## Response by Gas Transporters to Representation Received on NDM Proposals for 2007/08

Accordingly, in June 2007, NDM Profiling and Capacity Estimation Proposals for 2007/08 (dated 27<sup>th</sup> June 2007) were published electronically on the UK Link Documentation website. The published material comprised the proposals document and appendices, along with a set of additional electronic files containing the proposed NDM profiling and capacity estimation parameters and other supporting information.

In accordance with Section H1.8.3 of the Uniform Network Code, system users were invited to submit representations on the NDM proposals up to but not later than 15<sup>th</sup> July. As of that date one such representation had been received, from E.ON UK. This note is a formal response to the representation received.

**GRAPH 5.1 – NO LDZ, EUC BAND 2 DEMAND MODEL 2006/07**

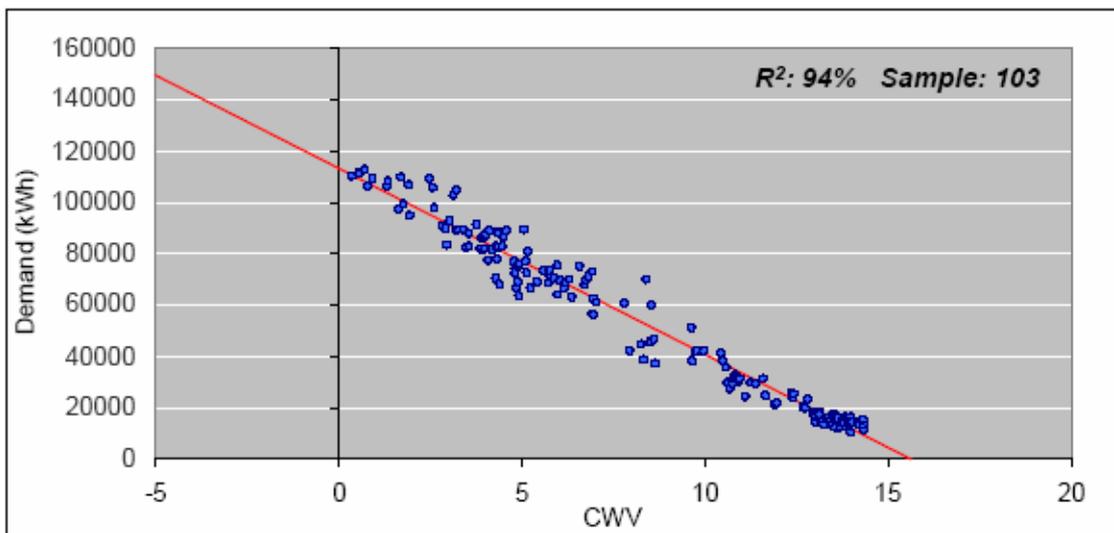
- Evidence from summer 2005 shows there are flaws in the CWV definition at warm temperatures. If evidence of global warming is to be believed then warmer summers have an increased likelihood into the future. We would request that Transporters undertake modelling to assess potential CWV changes in preparation for the 2008 analysis.

The body of the representation indicates that this point is based on slide 30 of the xserve presentation at the June 2007 Technical Forum. This is replicated below in Graph 5.1

This is the demand model for NO LDZ in Band 2 for the most recent analysis year (06/07). It is not the smoothed model eventually used in the proposals for 2007/08 (which would be an average of the three analysis years 2004/05, 2005/06 and 2006/07).

The cluster of data points at the extreme warm end lie on both sides of the straight line fitted and are within the scatter shown by the data set as a whole. The extreme hot weather of July 2006 corresponds to this sub-set of data points. The other data points referred to in the representation, (below the line at CWV values greater than approximately 12 degrees) do not appear more markedly deviant from the fitted line than other data forming this set.

Therefore the broader conclusion on CWVs drawn from this particular single model and data set concerns a different aspect of the modelling rather than flaws in the CWV relationship. The behaviour at the warm end of this 2006/07 data set is due to the overriding decision not to apply cut-offs to Bands 1 and 2 and is not due to a deficiency in CWV.
